ZONING AMENDMENT,
PLANNED UNIT DEVELOPMENT &
SUBDIVISION STAFF REPORT

Date: March 19, 2009

<u>NAME</u>	Reid Cummings
<u>SUBDIVISION NAME</u>	Snowden Place Subdivision
<u>LOCATION</u>	North side of Cottage Hill Road, 110'+ East of Christopher Drive East.
<u>CITY COUNCIL DISTRICT</u>	District 6
<u>PRESENT ZONING</u>	R-1, Single-Family Residential and R-3, Multiple-Family
<u>PROPOSED ZONING</u>	R-3, Multiple-Family
<u>AREA OF PROPERTY</u>	57 Lots / 13.3 ± Acres

SITE PLAN

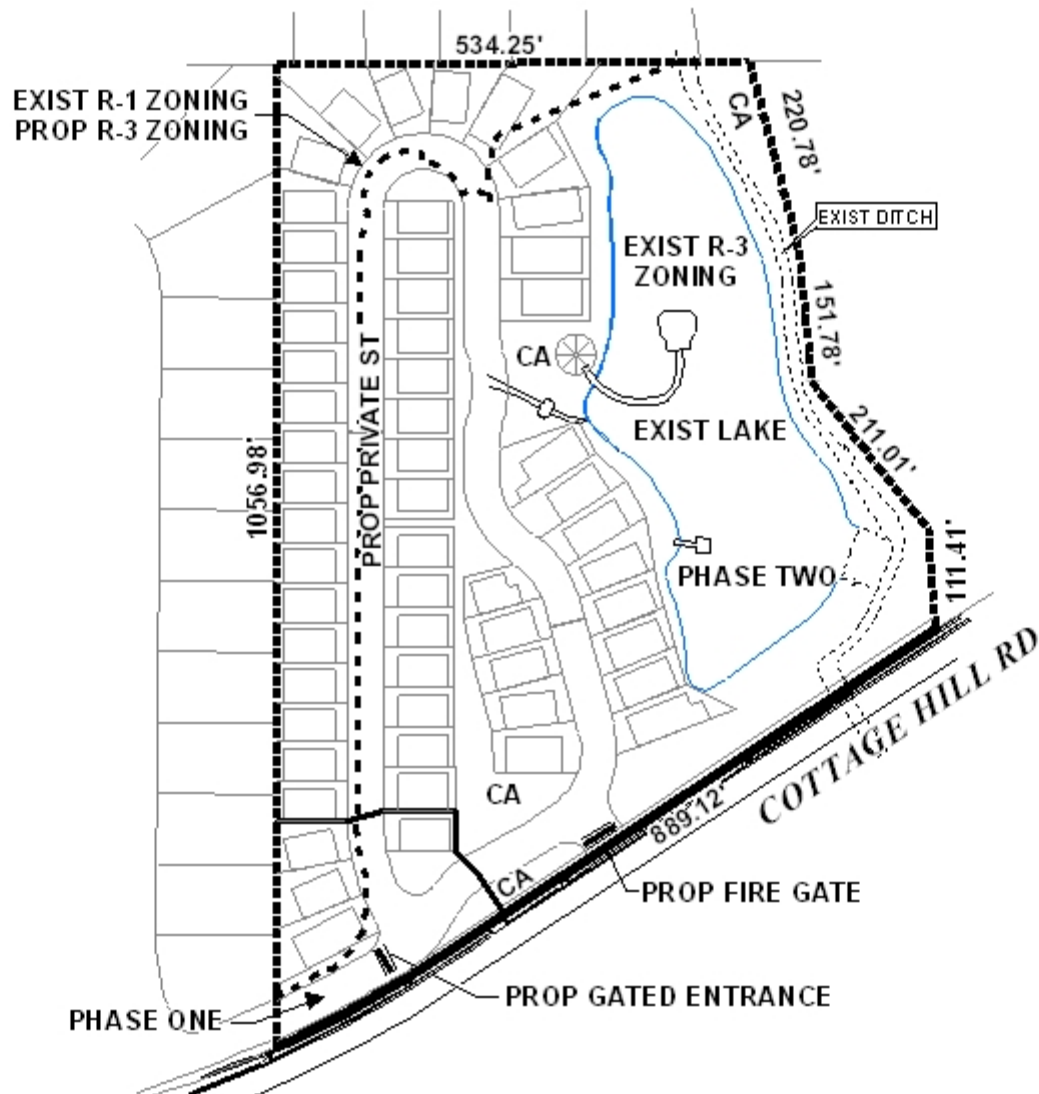
The site fronts onto Cottage Hill Road, a major street with a right-of-way of 80-feet (as depicted on the submitted site plan and plat, however, staff believes the right-of-way to be 100-feet). The right-of-way for this segment of Cottage Hill Road should be 100 feet, thus dedication sufficient to provide 50-feet from centerline is required.

The existing residence has a large wall along Cottage Hill Road. If the applicant intends to modify the wall to accommodate the revised main entrance and gate, it should be depicted on the site plan, and should be approved by Traffic Engineering for visibility issues prior to submittal of the revised PUD site plan.

As the proposed development will be a private, gated subdivision, city garbage collection may not be available. If a dumpster will be provided to serve the residents, it must be shown on the PUD site plan and must meet all required setbacks.

- 9) Revision of the site plan to label the correct width of the right-of-way for Cottage Hill Road, or dedication of right-of-way necessary to provide 50-feet, as measured from the centerline of Cottage Hill Road;

- 10) Revision of the site plan if the existing wall along Cottage Hill Road will be modified near the primary entrance from the service road stub, with approval of the revised wall design for traffic visibility issues by Traffic Engineering prior to the submittal of the site plan to Planning;

- 11) Revision of the site plan to depict a dumpster pad meeting setback and screening requirements, or placement of a note that individual private service will be provided;

- 12) Depiction of the 40-foot setback line from Cottage Hill Road, and the 15-foot setback line along the private street;
- 13) Revision of note number 17 on the PUD site plan and Subdivision plat to state that each lot is limited to the site coverage depicted on the table on the site plan and plat;
- 14) Provision of a revised PUD site plan to the Planning Section of Urban Development prior to the signing of the Subdivision plat; and
- 15) Full compliance with all other municipal codes and ordinances.

DETAIL SITE PLAN

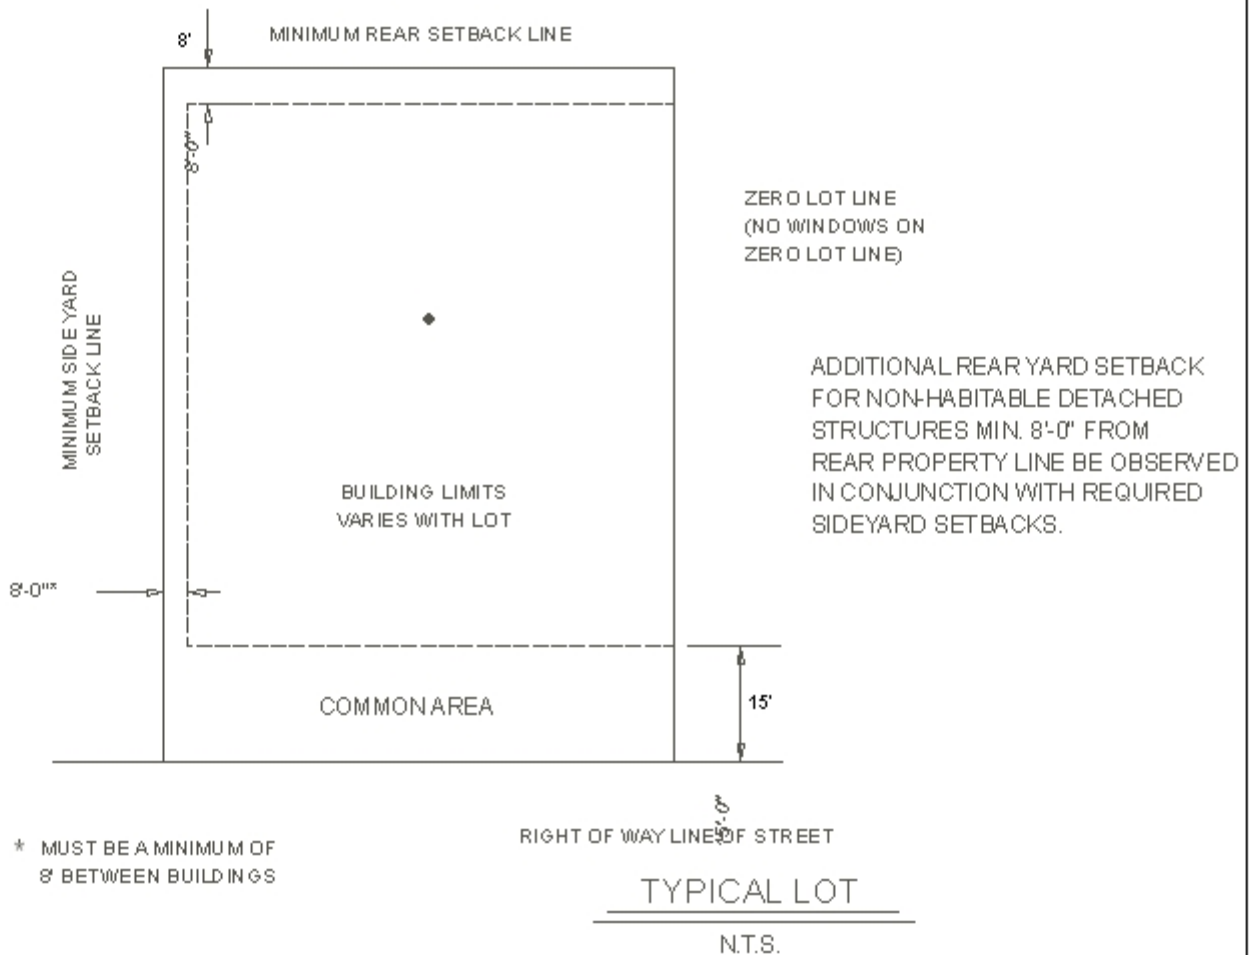
The building site for each lot will be setback 15-feet from the edge of the private street right-of-way, zero feet from one side yard, 8 feet on the other side yard, and 8 feet from the rear property line. The setbacks are depicted on the site plan and plat, and a typical example is also shown on both drawings. Each lot will have an individual site coverage ratio, which is shown on a table on the plat and site plan.
